From: ANIL KUMAR REDDY.S <civil.anils@gmail.com>
Sent: 12 10 2018 12:57 PM
To: purshotham K
Cc: Soham Modi; karunakar
Subject: Regarding FFL for villa no. 35,36,37

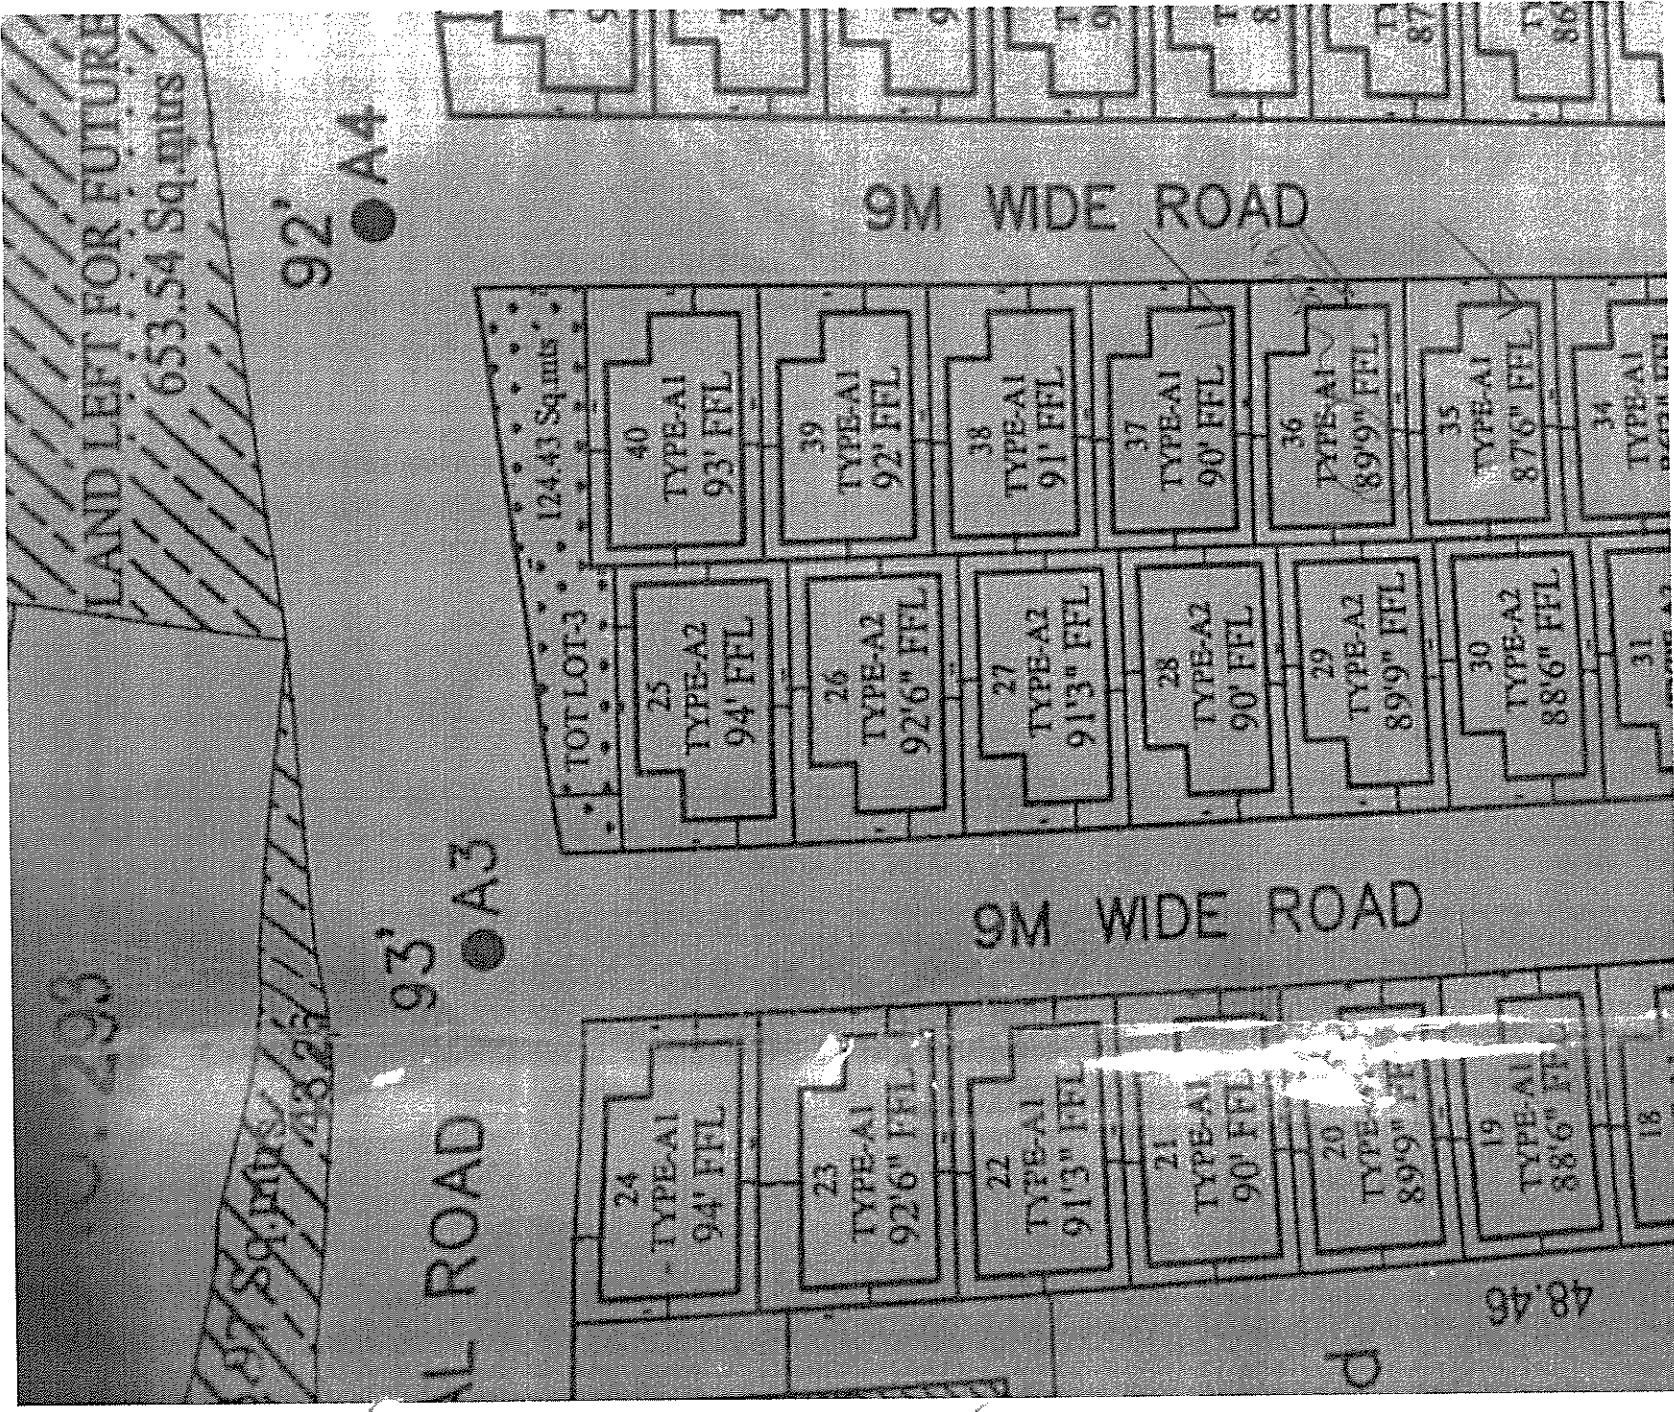
As per the approved drawing

Villa no. 37 FFL is 90'

Villa no. 36 FFL is 89'9"

Villa no. 35 FFL is 87'6"

There is a 2'3" level difference between villa no. 35 & 36.

And only 3" level difference between villa no. 36 & 37.

Please clarify the levels so that we can proceed with the works.
